1	AIRPORT COMMUNITIES COALITION,)	No. _____
2)	
3	Appellant,)	ACC'S NOTICE OF APPEAL OF
4)	REISSUED/AMENDED SECTION 401
5	v.)	CERTIFICATION, INCORPORATING
6)	ACC'S PRIOR NOTICE OF APPEAL
7	DEPARTMENT OF ECOLOGY; and)	AND ACCOMPANYING EXHIBITS
8	THE PORT OF SEATTLE,)	AND DOCUMENTS
9)	
10	Respondents.)	(Department of Ecology "Order No. 1996-
11)	4-02325 (Amended - 1)," Issued
12)	September 21, 2001)

The public notice from the U.S. Army Corps of Engineers (Corps) for proposed work has been reviewed. On behalf of the state of Washington, we certify that the work proposed in the Port of Seattle's (the Port's) revised Joint Aquatic Resource Permit Application (JARPA) dated October 25, 2000, the Corps' public notice and the Department of Ecology's (Ecology's) public notice complies with applicable provisions of Sections 301, 302, 303, 306 and 307 of the Clean Water Act, as amended, and other appropriate requirements of state law. This letter also serves as the state response to the Corps. This letter also serves as notification that Ecology has rescinded Order Number 1996-4-02325 issued on August 10, 2001 and replaced it with Order Number 1996-4-02325 (Amended-1) issued on September 21,

Revised Auburn Grading Plan (June 28, 2001):

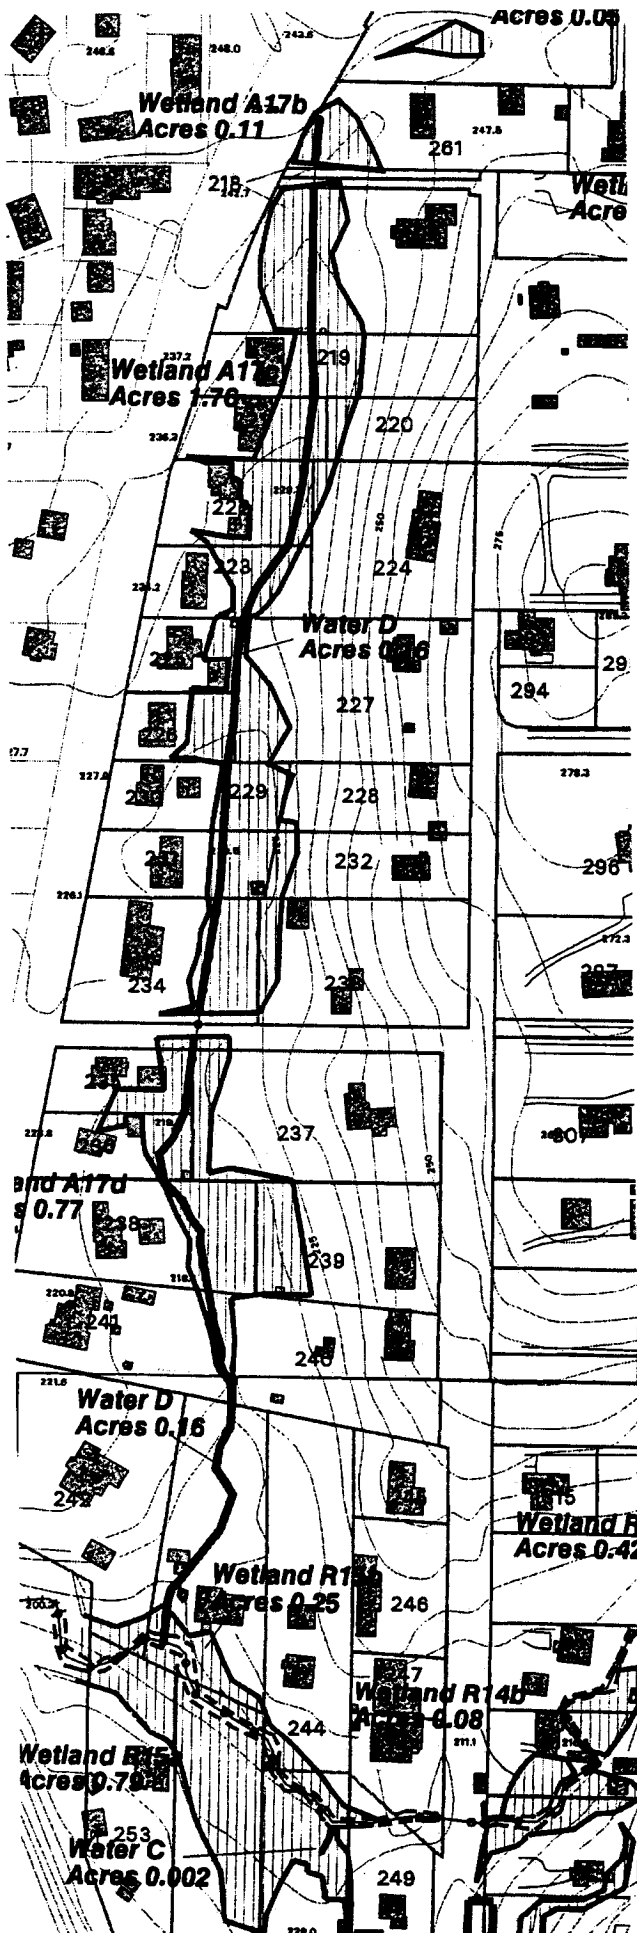
1. The revised grading plan (June 28, 2001) shows a culvert in the northwest corner of the site in the proposed new drainage swale. The culvert will pass flows under the site access path. The drawing shows this culvert approximately 60 feet long, passing under a path that is only approximately 15 feet wide. This culvert should be no longer than is necessary to pass the water under this pathway.
2. The revised grading plan (June 28, 2001) shows a culvert in the south central portion of the mitigation site. This culvert appears to be mis-located. It appears that the culvert should be shown in the wetland directly east of the shown location, where the wetland passes under the

Borrow Area 3 Wetland and Swale Buffer

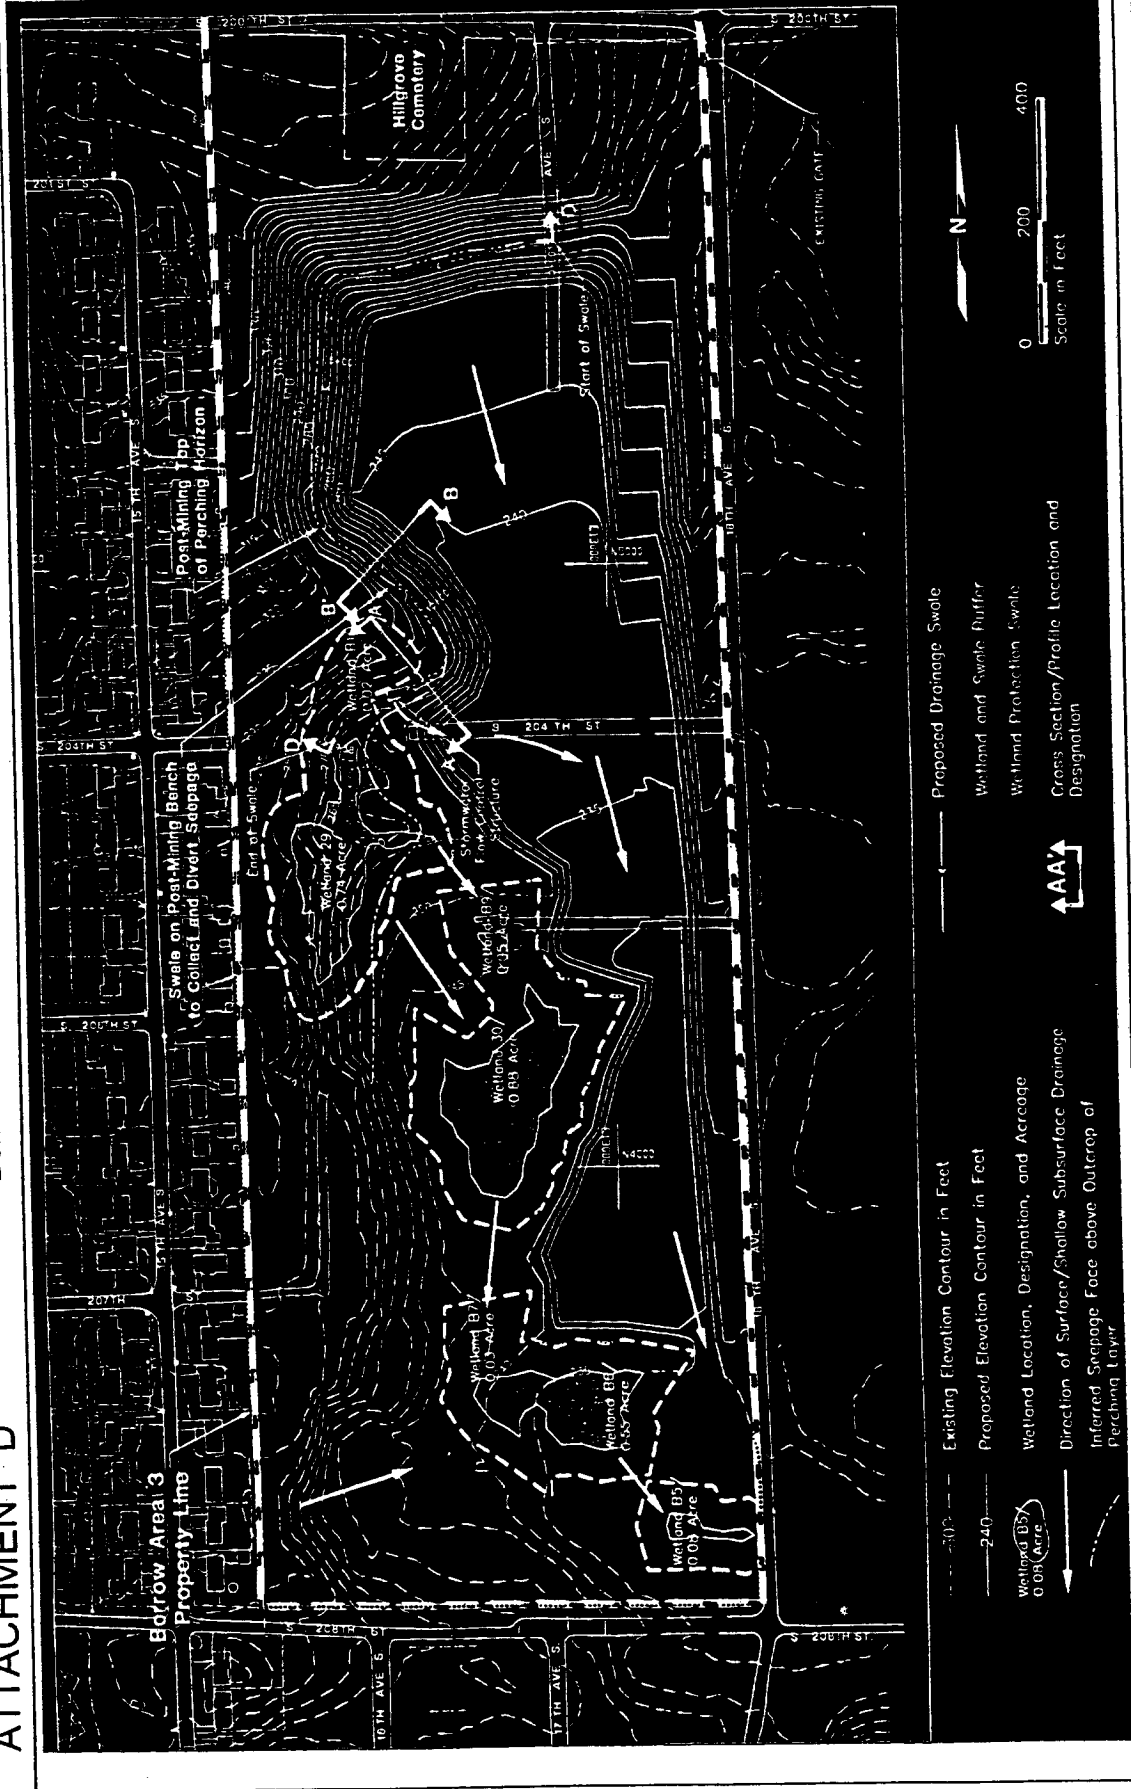
- a) The site plan from Hart Crowser titled Post Reclamation Topographic detail Borrow Area 3 Wetland Protection Swale HNTB revision (June 15, 2001 Draft) shows a flow dispersal trench overlapping with a small portion of Wetland 29. The flow dispersal trench shall not be constructed so that it is in the wetland.
